MEMORANDUM

Subject: Construction Review Report – Great Falls District
STPS 218-1(10)19
East of Conrad - East
Control Number: 6977
Contract Number: 10710

CONSTRUCTION ENGINEERING SERVICES PROJECT REVIEW REPORT

Project Number:	STPS 218-1(10)19	Letting Date:	29 July 2010
Project Description:	East of Conrad – East	MDT District:	Great Falls
Control Number:	6977	EPM:	Mike Klette
Contract Number:	10710		
Review Date:	16 June 2011		
Reviewed By:	Terry W. Wickman	In Company With:	Mike Klette, EPM Dan Ferestad, CET 5
Project Description:	<p>The project is located on State Secondary Route 218 in Pondera and Liberty Counties, beginning at RP 18.8 east of Conrad and extending east and north approximately 6.9 miles to RP 25.9.</p> <p>The work consists of either a cold in-place recycling paving option, or cold milling and Grade S Plant Mix Surfacing option. Other improvements consist of guardrail and bridge rail improvements, seal and cover, and other miscellaneous improvements.</p>		
Review Type:	<input type="checkbox"/> Constructability <input type="checkbox"/> Investigatory <input checked="" type="checkbox"/> Oversight <input type="checkbox"/> Post Construction <input type="checkbox"/> Subj

Cold Recycle Width of 25.0' Proposed by Contractor – Leaving 6" +/- “Wedge” of Existing Plant Mix @ Each Edge

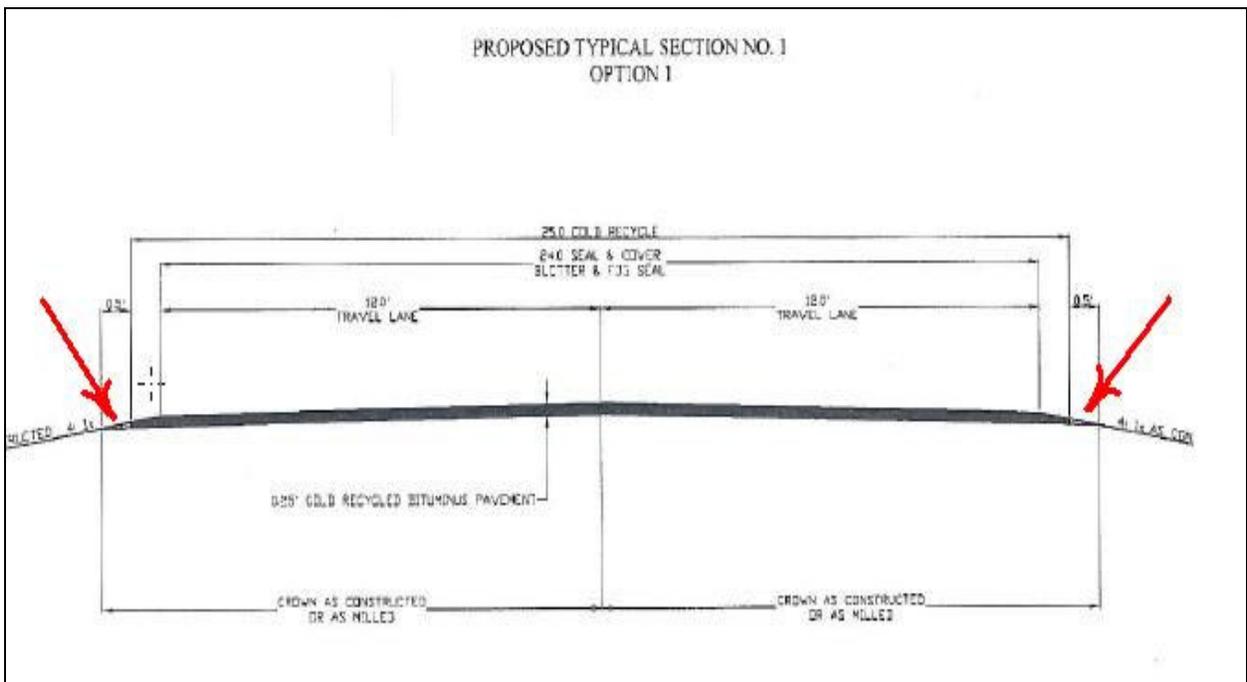
The plans called for the existing plant mix to be milled and recycled to a depth of 0.25' over the full-width of the roadway (26.0' to 26.6' per Typical Sections). The Contractor submitted a proposal to mill to an overall width of 25.0', which would leave an approximately 6" wedge of existing plant mix along each edge of pavement. Their rationale was that the remaining wedge of material would provide lateral constraint to minimize rollout and shoving during compaction, as well as reduce the risk of the mat breaking after the work is completed.

This proposal was reviewed by the MDT Pavement Analysis Section. They expressed concern that, if more than 6" of existing plant mix were to remain on the edges, it could lead to sympathy cracking from the existing

transverse cracks. While it was not discussed specifically during this review, it should also be noted that with the plan design requiring only a partial depth of the plant mix be milled (i.e., 0.25'), the recycled mat may also be subject to premature reflective cracking from the existing plant mix remaining after milling.

The District was receptive to this proposal and issued Change Order No. 2 for this change.

Cold In-Place Recycling Paving (CIPR) Equipment “Train” – Approximately 185’ in Length

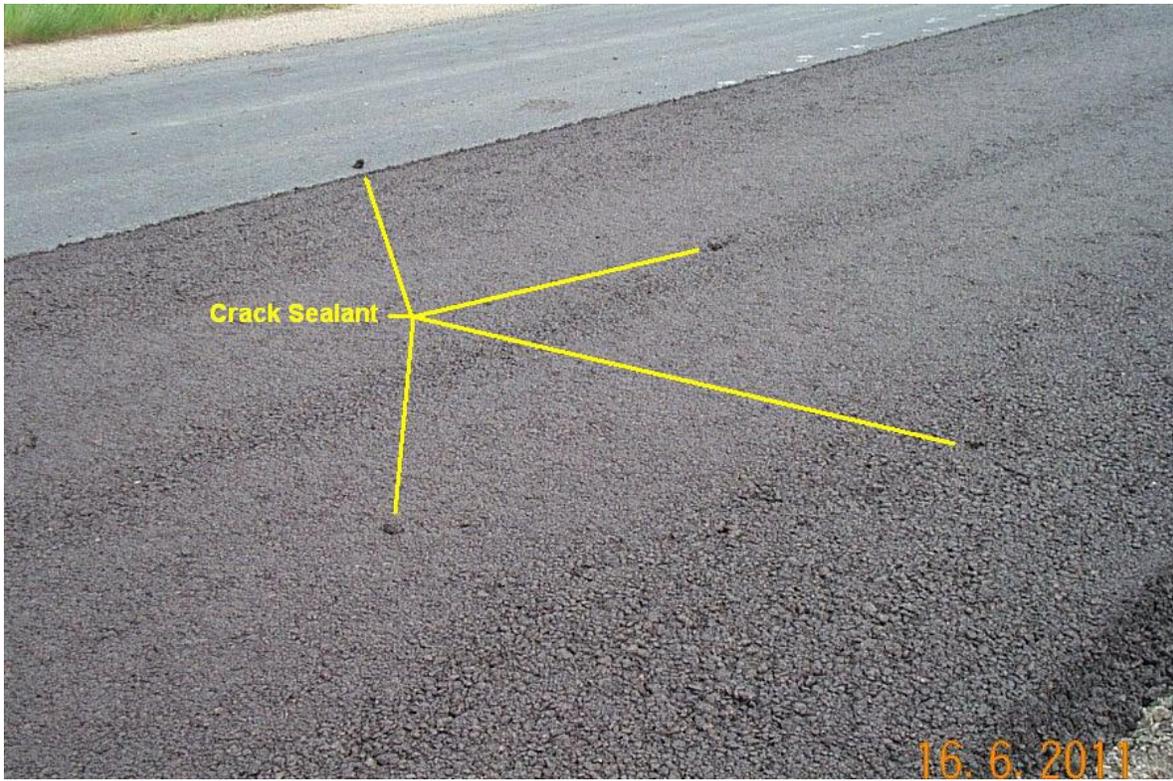
The mechanically-coupled equipment “train” extended some 185’ (±) and consisted of the following equipment: 1-water tender truck; 1-lime slurry tanker trailer; 1-cold milling machine (w/12.5’ cutting head); 1-vibratory screen deck/crusher combination unit; 1-pugmill-type reclaimer/blending unit; 1-asphalt emulsion tanker (pup); 1-paver w/pickup attachment; 2-tandem, steel drum rollers and 1- rubber-tire roller. The length of the “train” does not include the paver or rollers.
